### APPEAL SUMMARY

<b>Appeal ID:</b> 15287	<b>Project Address:</b> 55 NE Grand Ave
<b>Hearing Date:</b> 7/12/17	<b>Appellant Name:</b> Doug Benson
<b>Case No.:</b> B-029	<b>Appellant Phone:</b> 5038869757
<b>Appeal Type:</b> Building	<b>Plans Examiner/Inspector:</b> Jerry Englehardt
<b>Project Type:</b> commercial	<b>Stories:</b> 6 <b>Occupancy:</b> S-2, A-2, R-2, B <b>Construction Type:</b> III-A
<b>Building/Business Name:</b>	<b>Fire Sprinklers:</b> Yes - throughout
<b>Appeal Involves:</b> Alteration of an existing structure	<b>LUR or Permit Application No.:</b> 14-216353-CO
<b>Plan Submitted Option:</b> pdf [File 1] [File 2] [File 3] [File 4]	<b>Proposed use:</b> MIXED USE - RESIDENTIAL AND COMMERCIAL

**Code Section** NFPA 13 8.15.1.2.1.8

**Omission of fire sprinklers in roof top patio enclosure: Denied. Proposal does not provide equivalent Fire / Life Safety protection.**

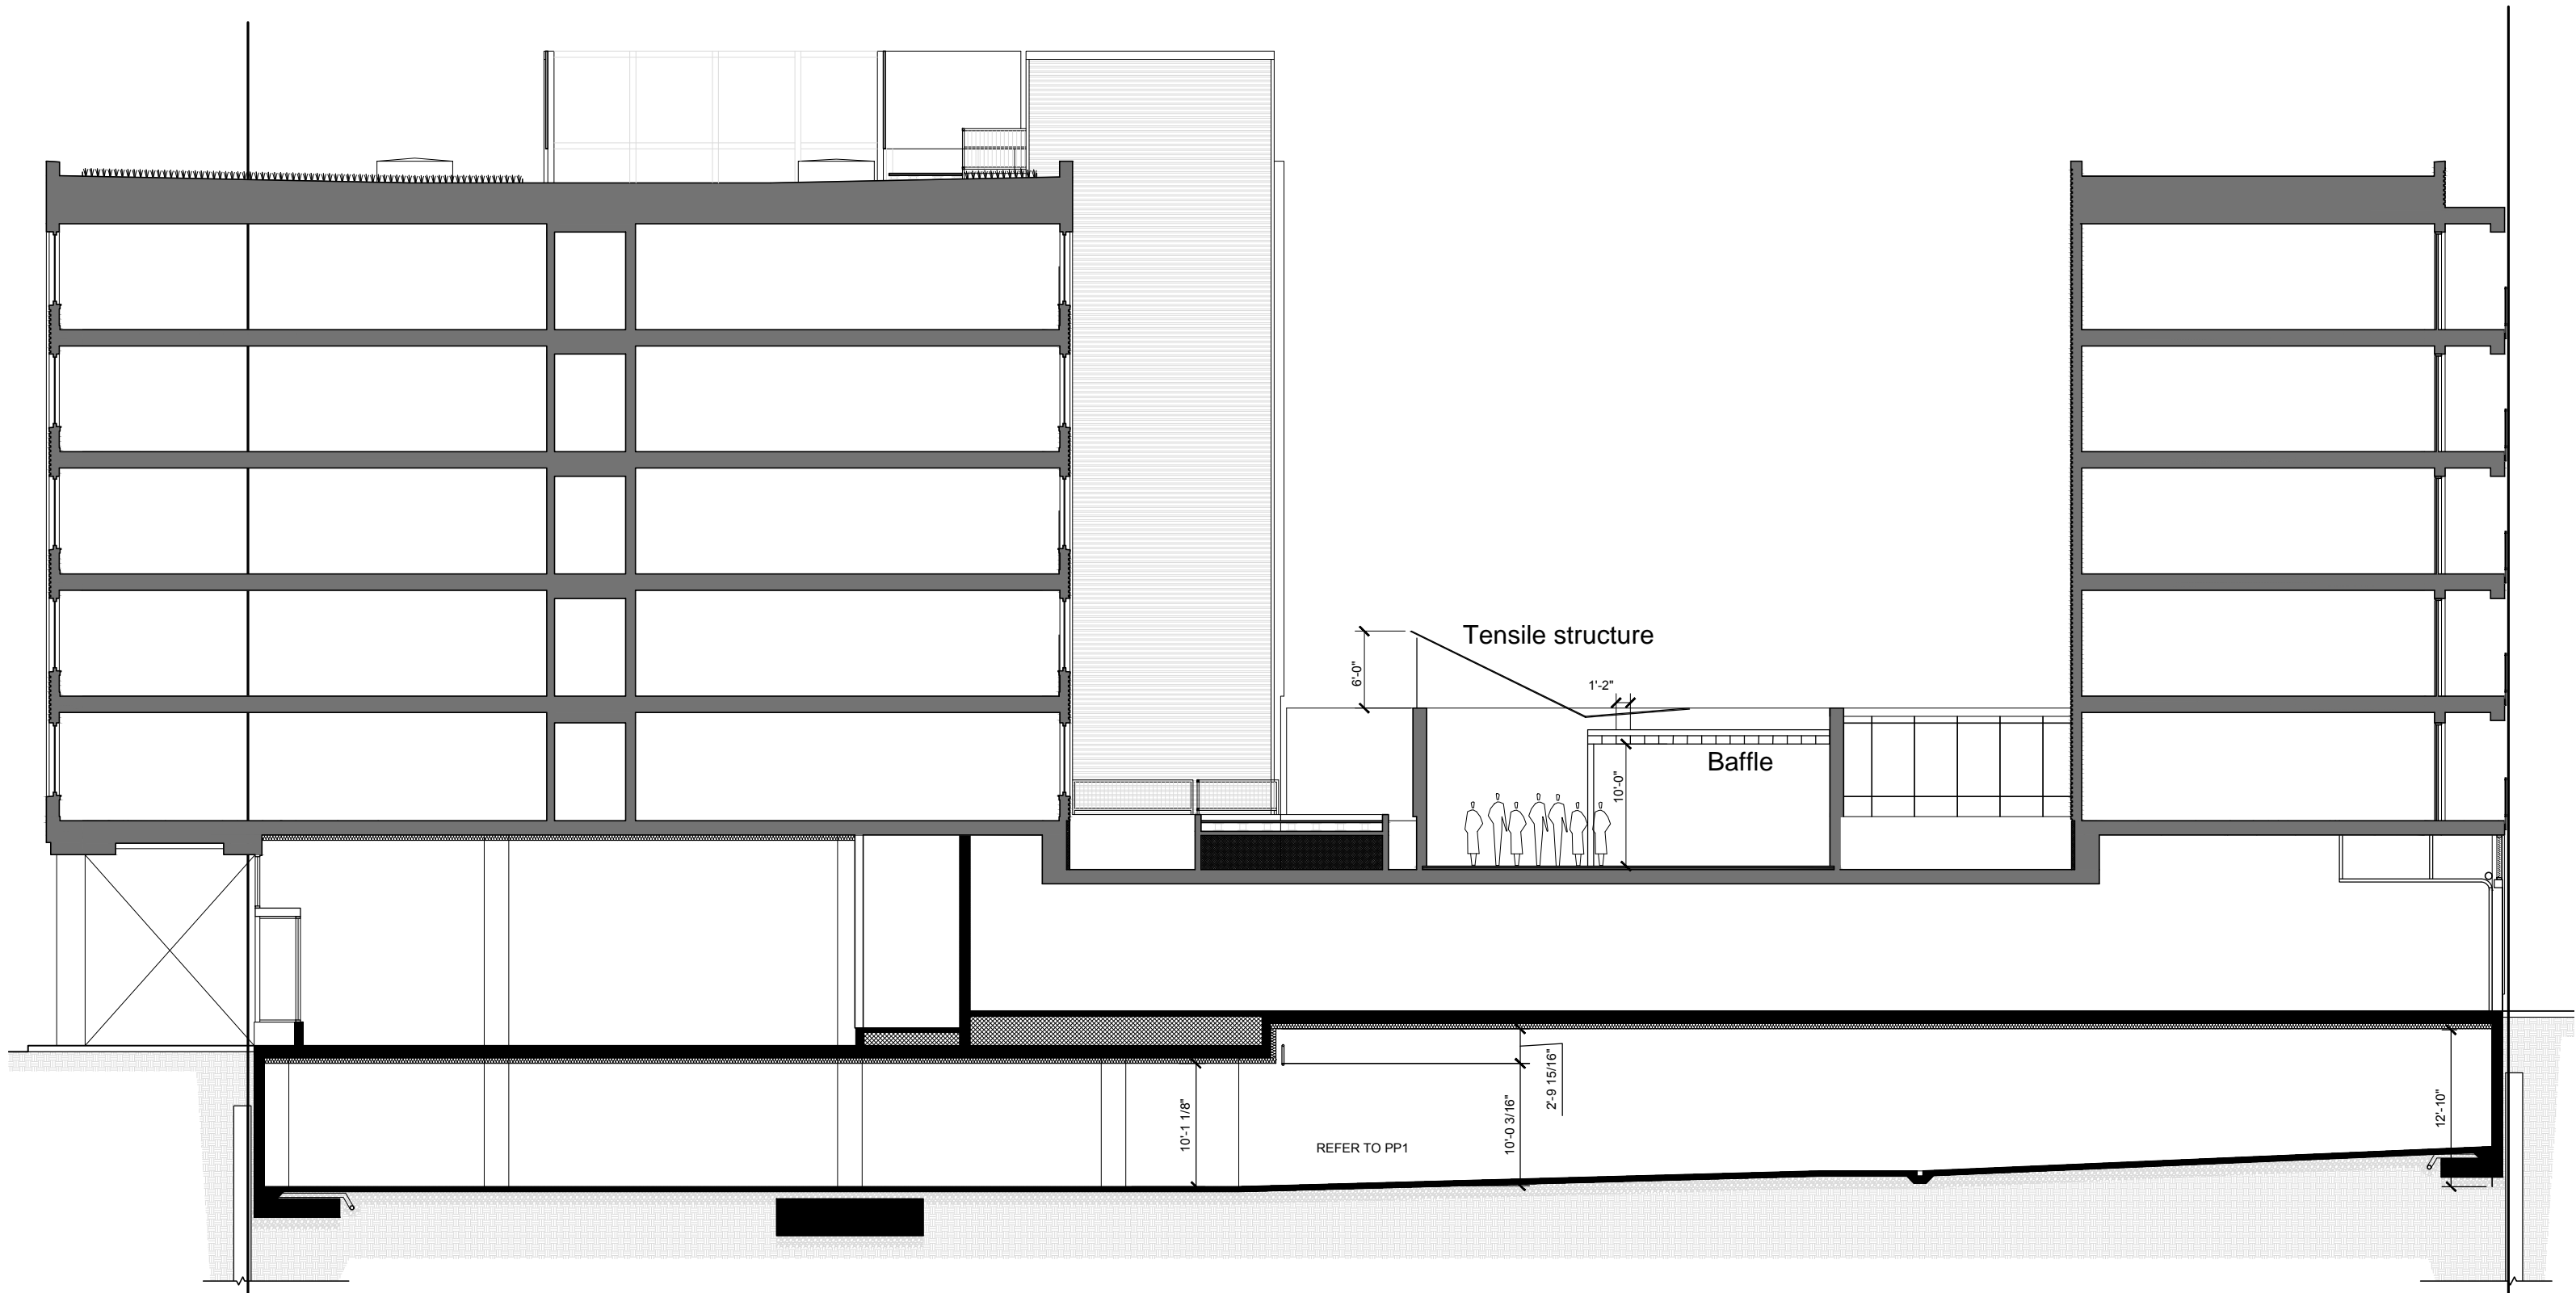
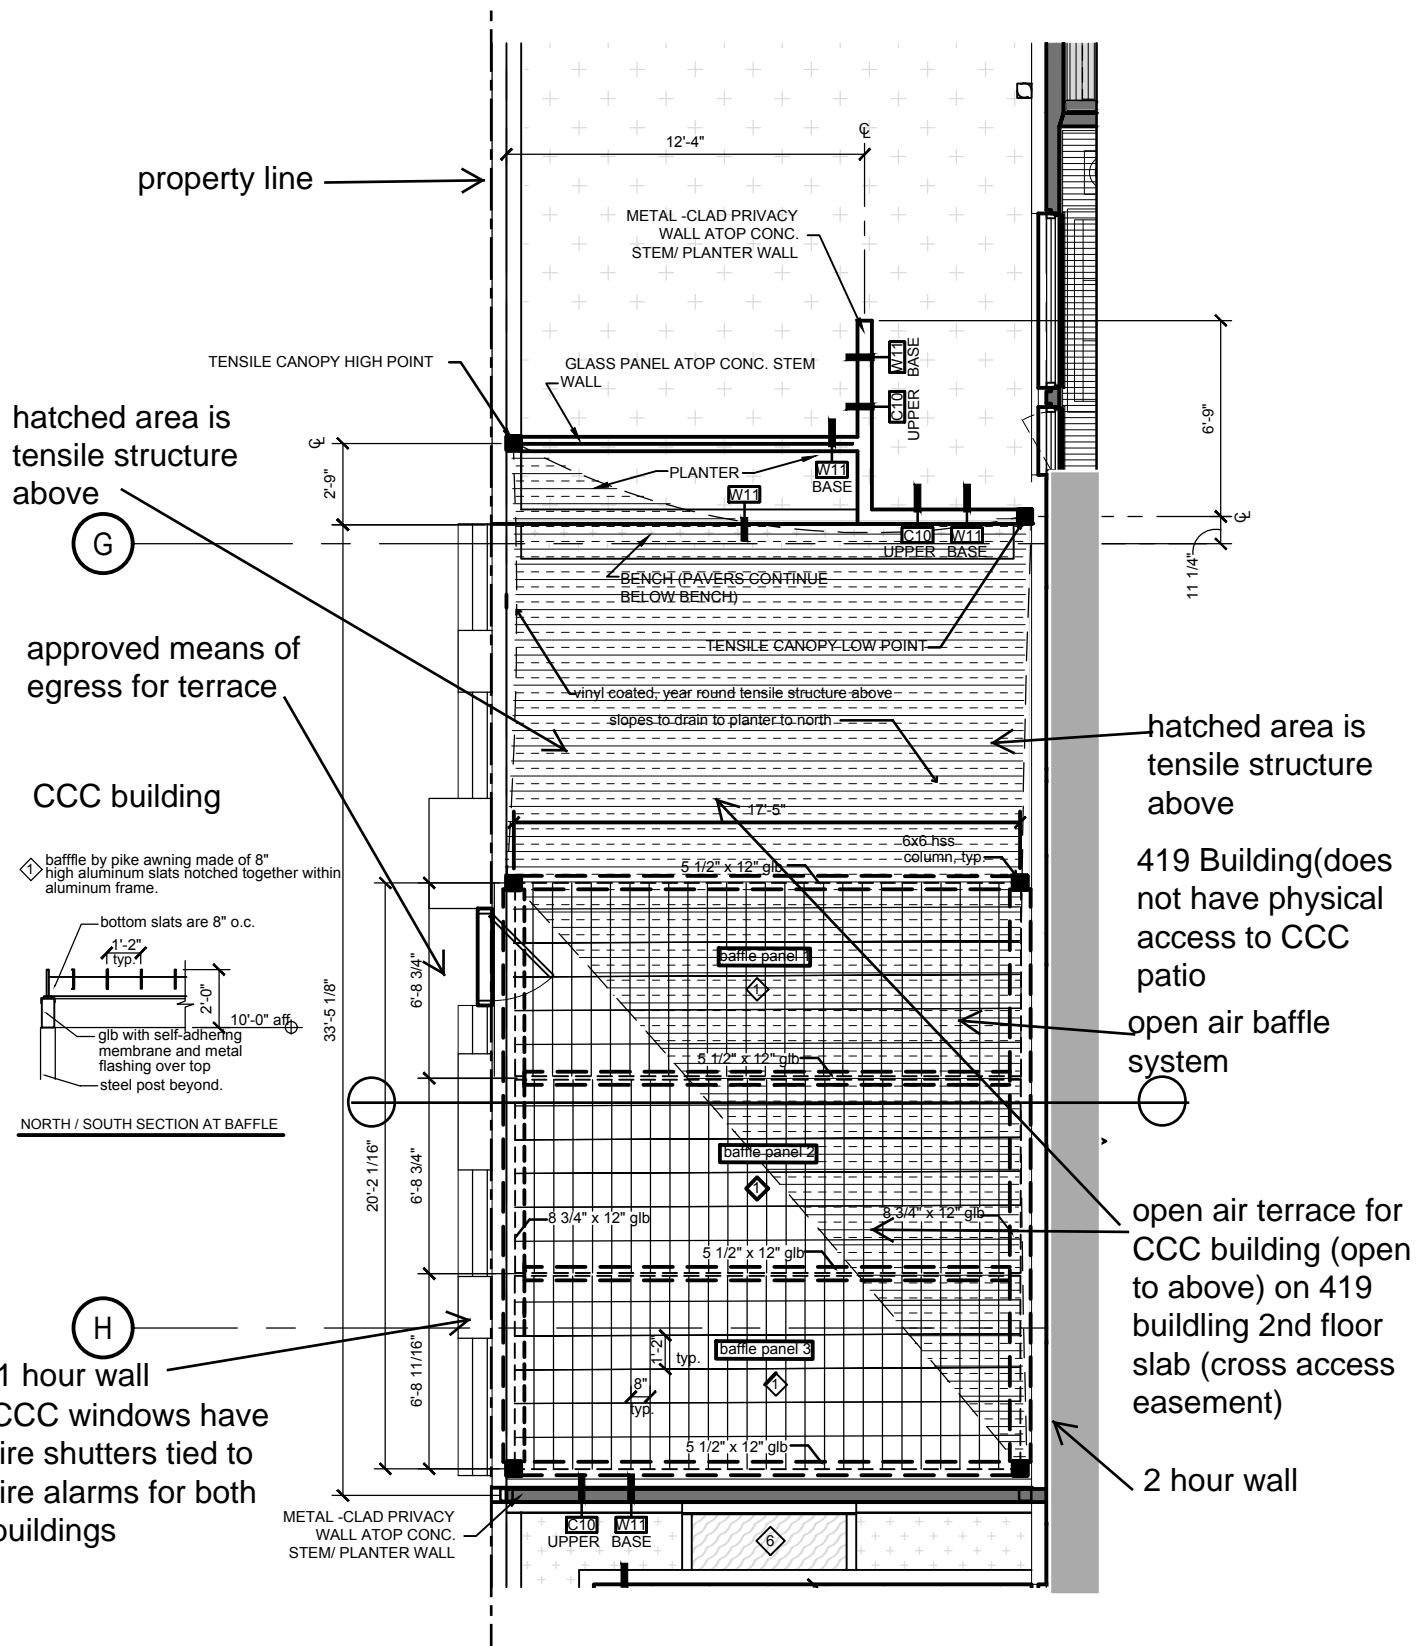
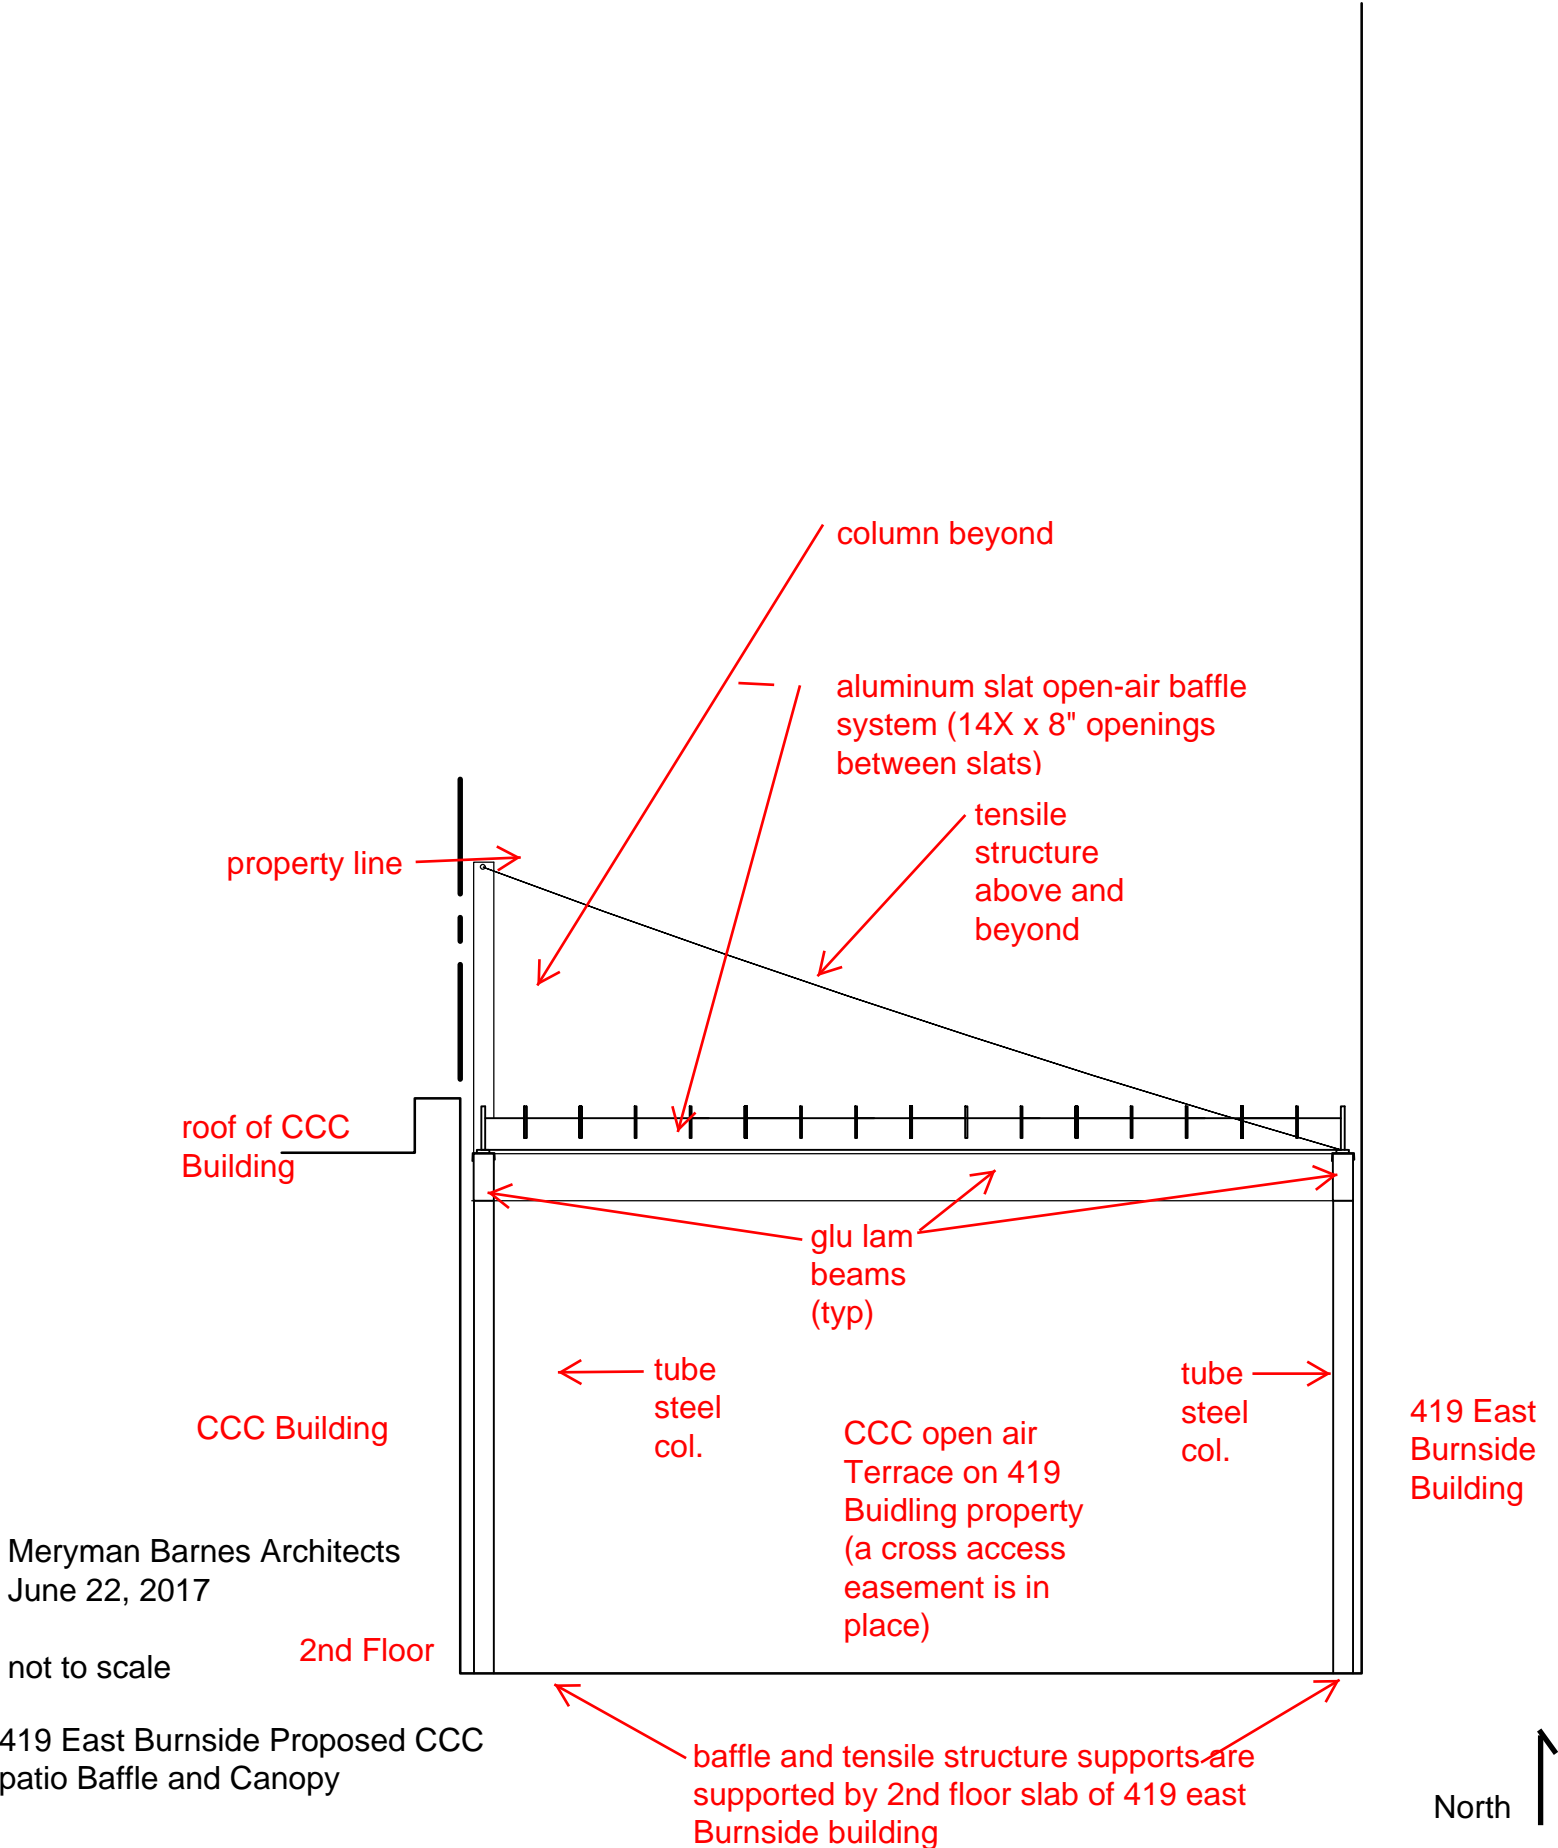
**Proposed Design** The subject of this appeal is for an open air rooftop canopy structure. Its purpose is to provide visual privacy, as required by the Federal HIPAA rules, for the residents of the Central City Concern Hopper Detox facility from direct visibility by residents of the adjacent apartment building. There is a cross access easement which allows the CCC function exclusive use of the 2nd floor roof patio that is created in the 419 Building property. The structure is composed of glu-laminated columns and beams as the primary structural support. Between the structural elements a series of baffles composed of non-combustible aluminum slats arranged into two way grids are attached to cut off visibility from above. The glu-laminated members meet the requirements for Heavy Timber as defined by the code. The entire assembly is open on all sides and to the sky between the baffle members. Situated well above the canopy structure, at a height of 12' and extending up to 18', is a non flammable fabric sail meeting NFPA 701 that covers a portion of the exterior deck to provide further visual protection for the detox center's residents.

The proposed rooftop canopy structure is located on the roof of the apartment project garage immediately adjacent to the Hopper Detox facilities exterior wall. The building's wall provides a 1 hour barrier and is further protected by the addition of fire shutters at all exterior windows along the shared wall. The patio The adjacent wall of the 419 East Burnside Building to the East has a 2 hour wall with no openings at the patio level.

Furthermore, the patio cannot be used for storage and the residents using it are strictly monitored at all times.

**Reason for alternative** The degree of openness of the baffle system, together with the angled design of the tensile canopy above it, will prevent heat from building up enough under these structures for sprinklers to be activated.
